ADDENDUM NO. 1

Plans & Specifications for: Elsie Turner Field & Graverson Playground, Waltham, MA

In accordance with documents prepared by: Carolyn Cooney & Associates

DWG No. **L.614**

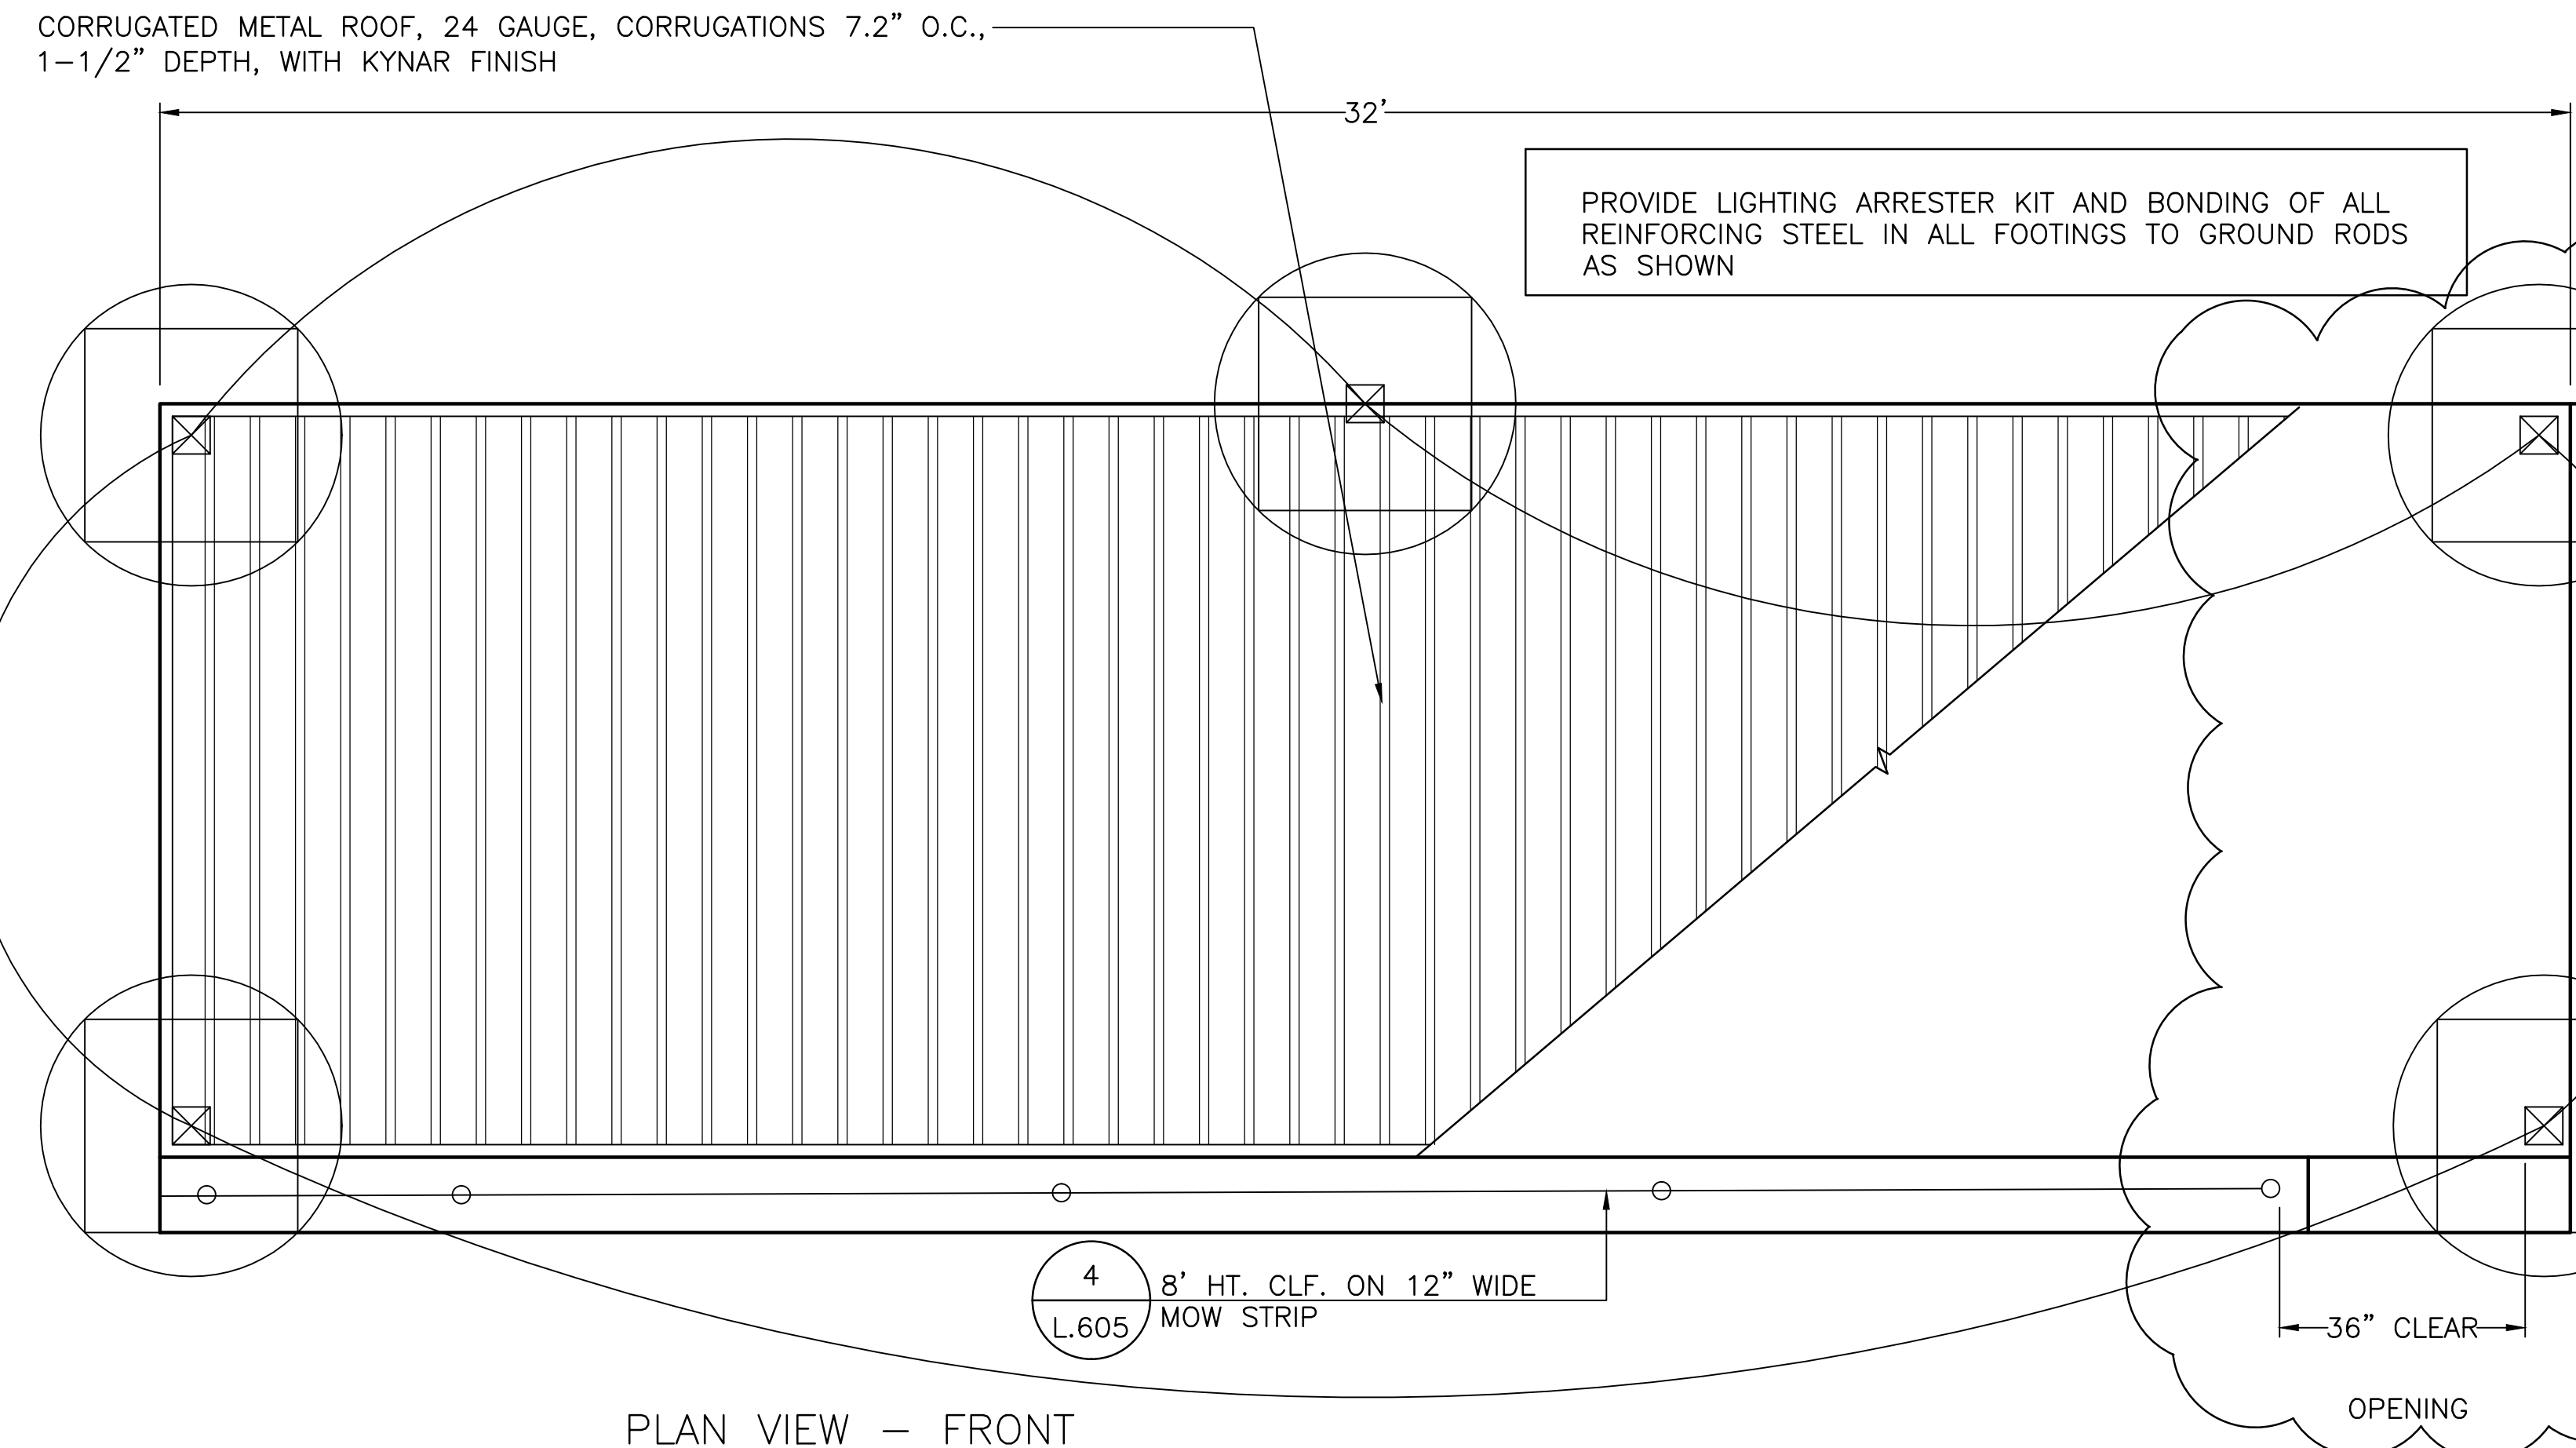
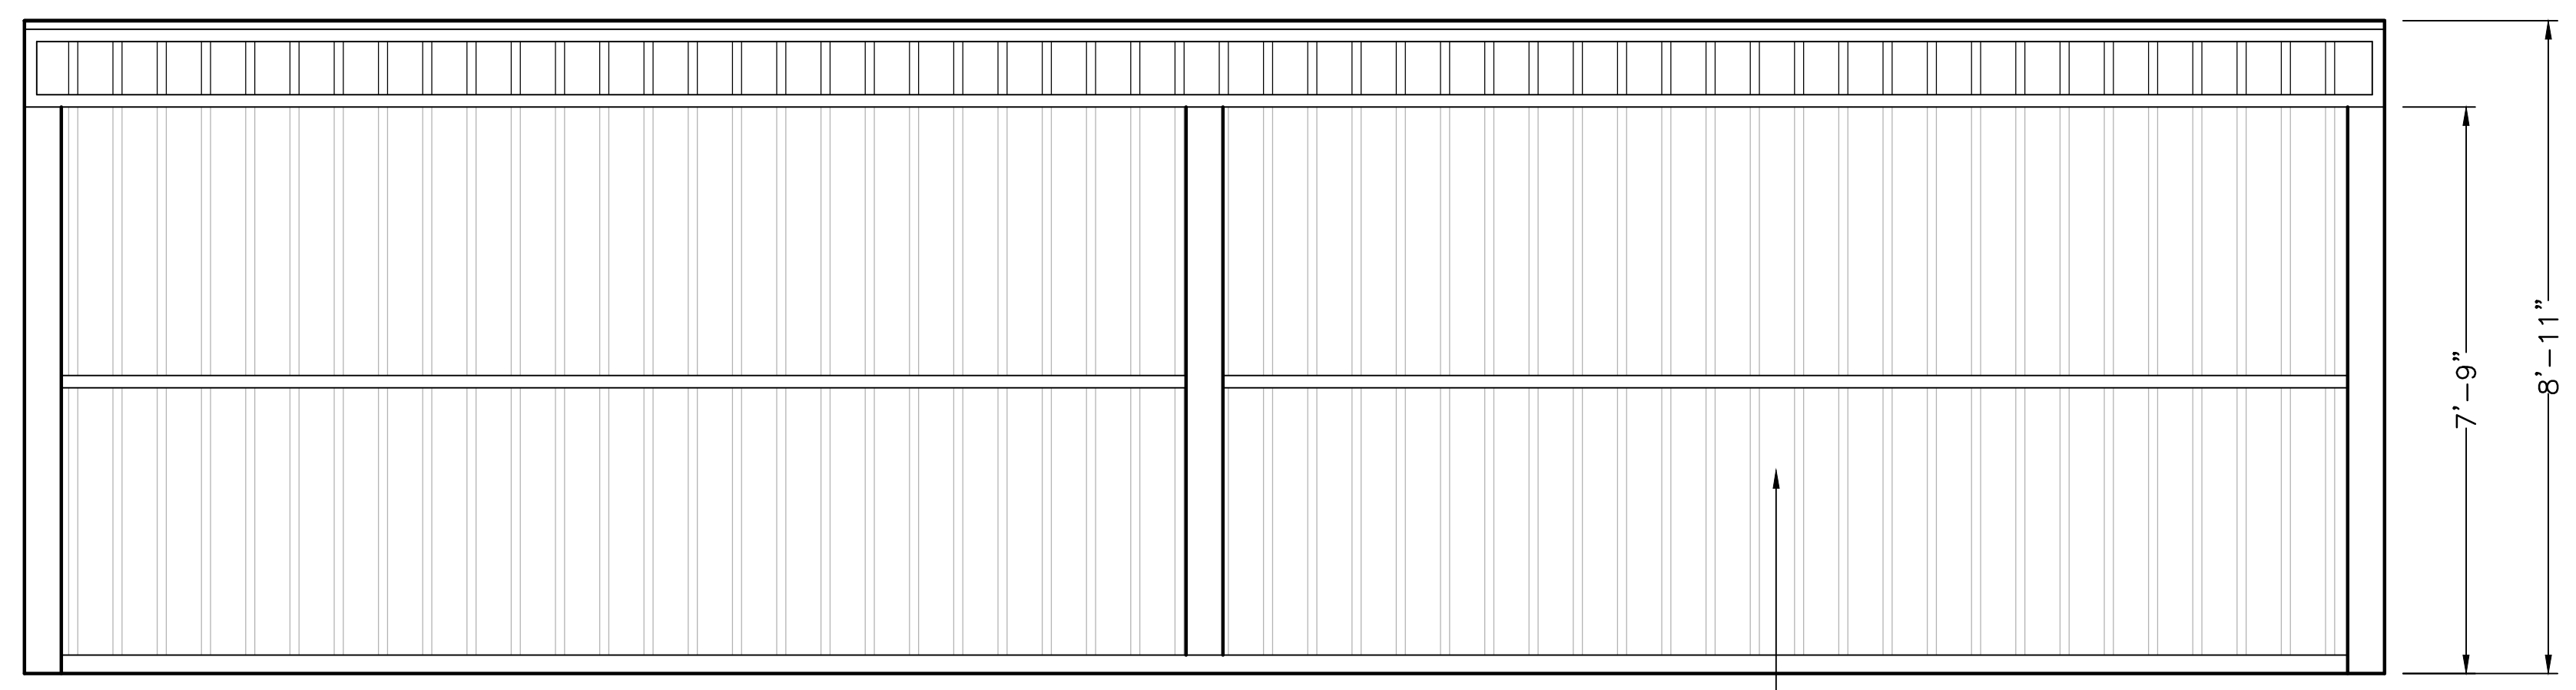
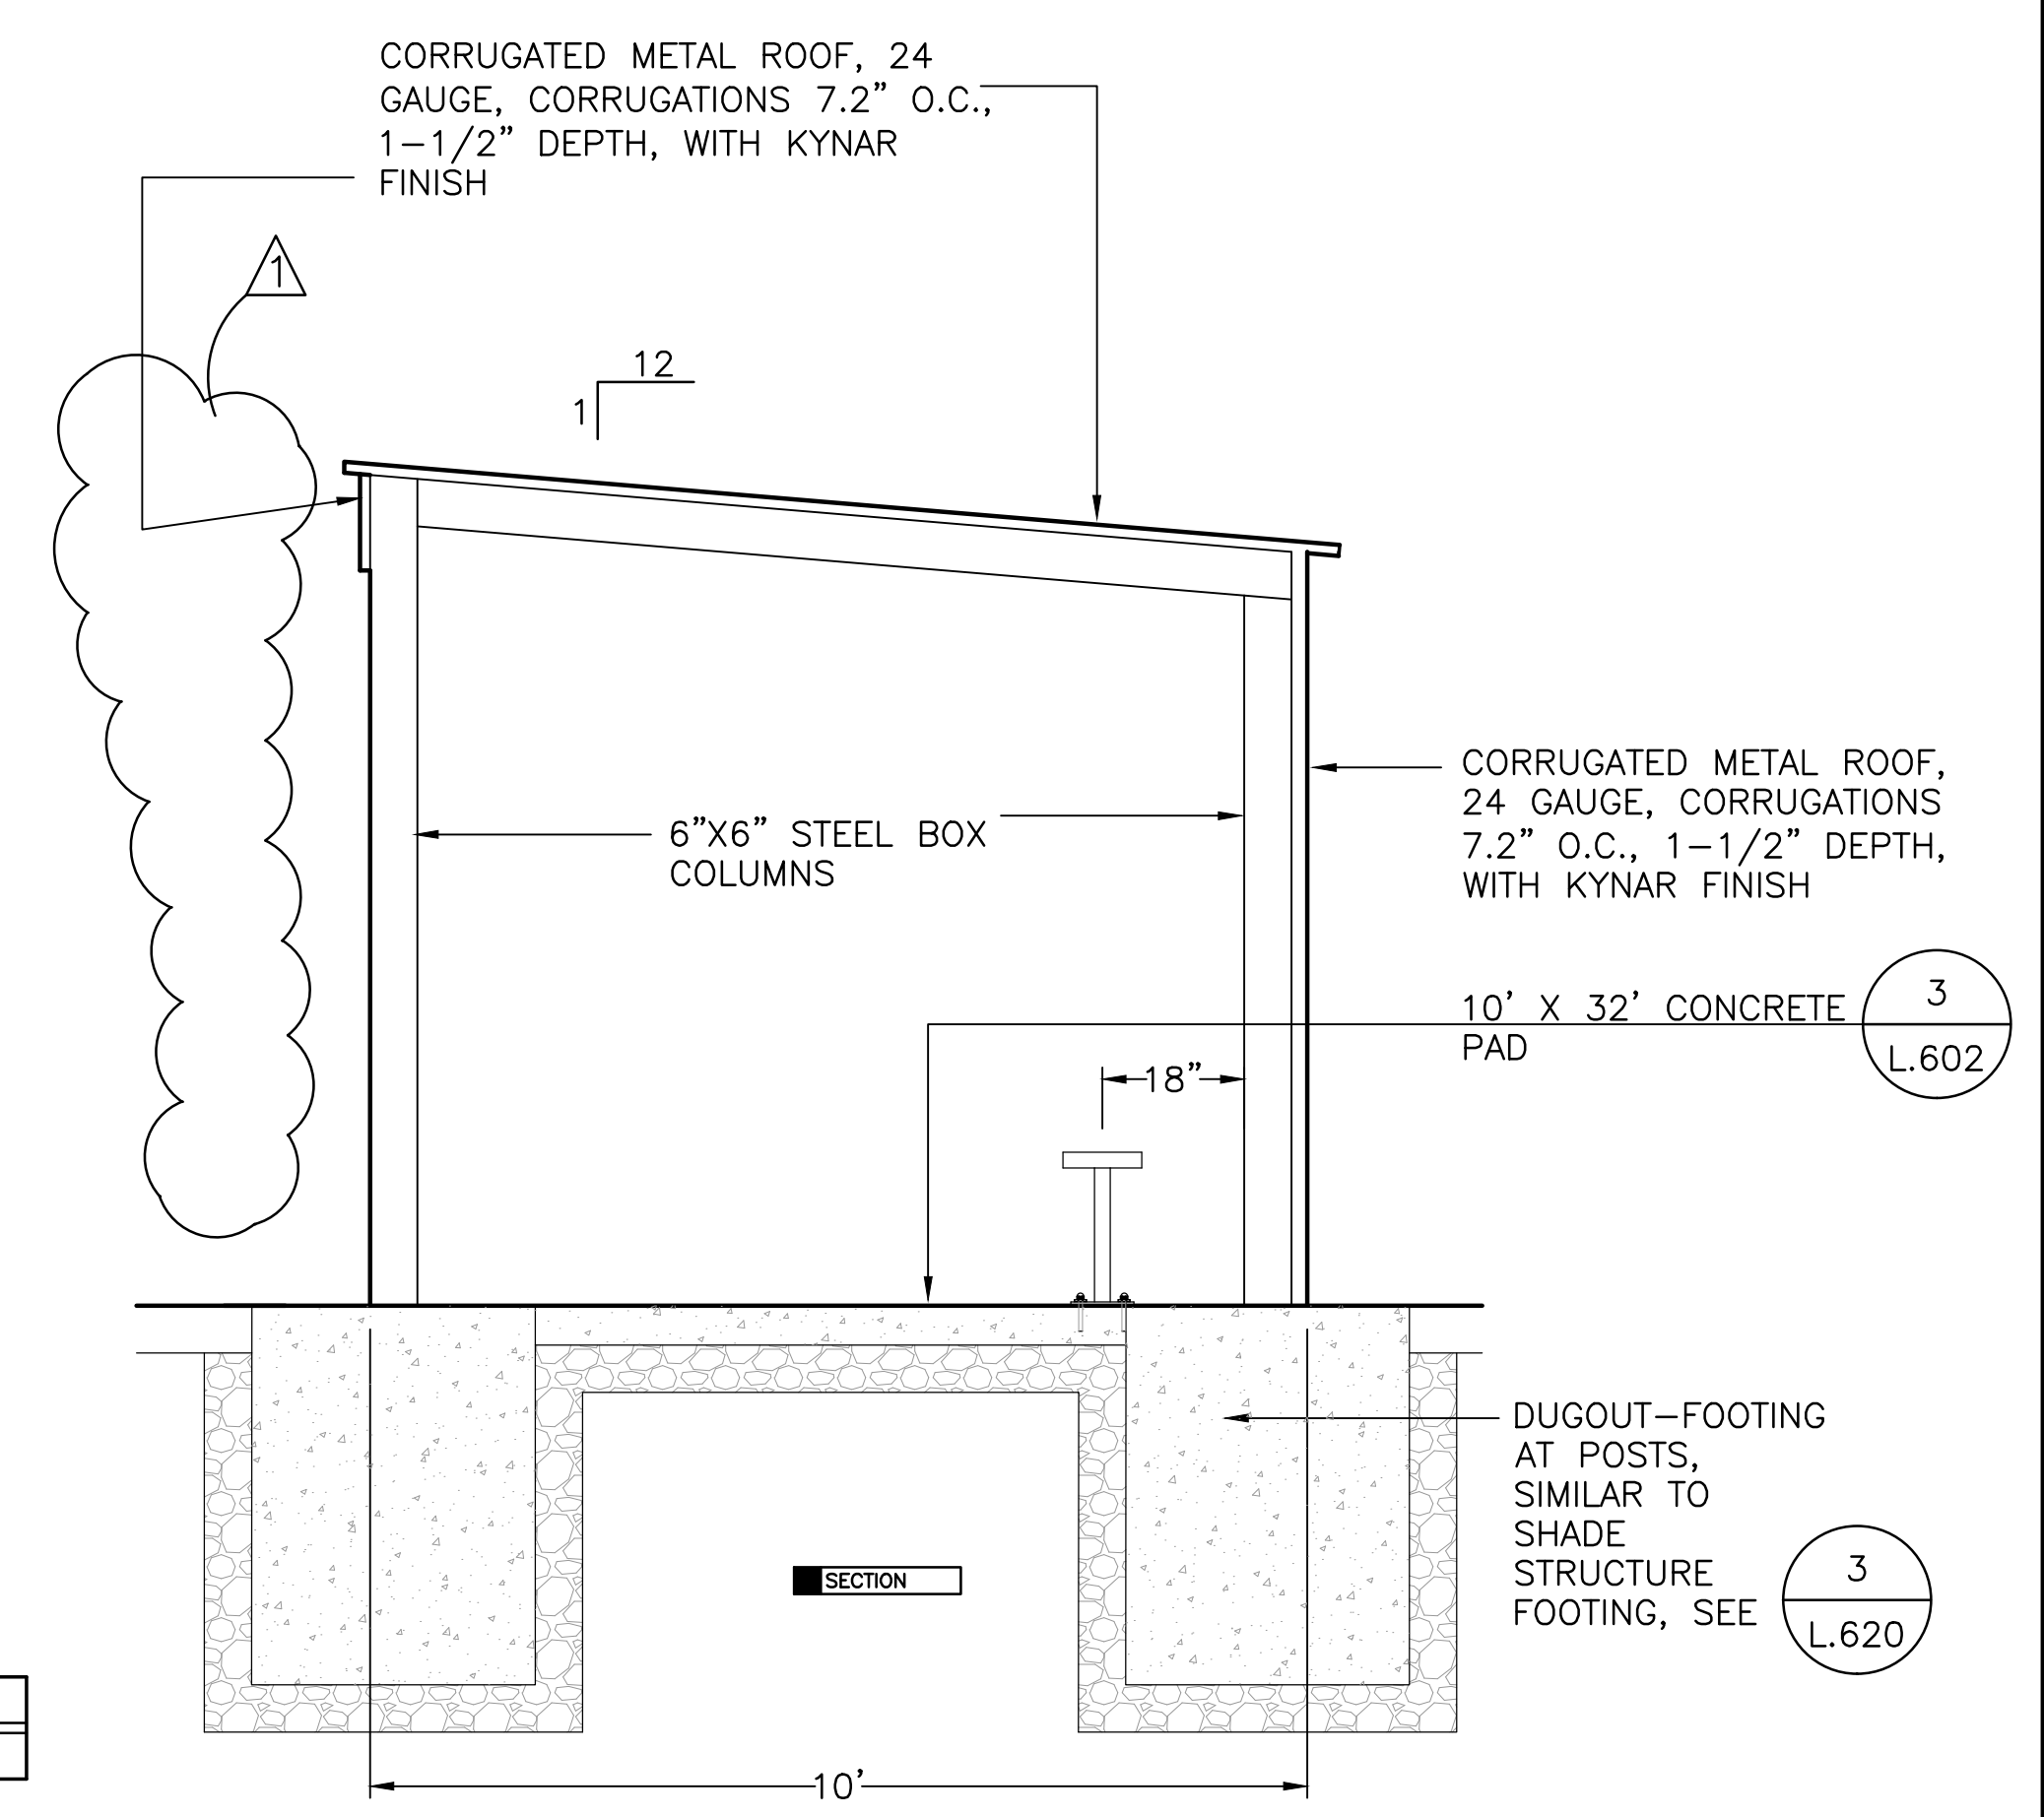
- ITEM NO. 24** *Elsie Turner Field: Replace Drawing L.614 with new drawing L.614 attached.
Revision is to delete a portion of chain link fencing at dugouts.*
- ITEM NO. 25** *Elsie Turner Field: Add new drawing L.624, attached.*
- ITEM NO. 26** *Elsie Turner Field: Replace Drawing ES.1A with new Drawing ES.1A attached.
Revision is to number of light fixtures.*
- ITEM NO. 27** *Elsie Turner Field: Replace Drawing ES.2 with new Drawing ES.2 attached.
Revision is to number of light fixtures, and correction to Control Cabinet Detail connections.*
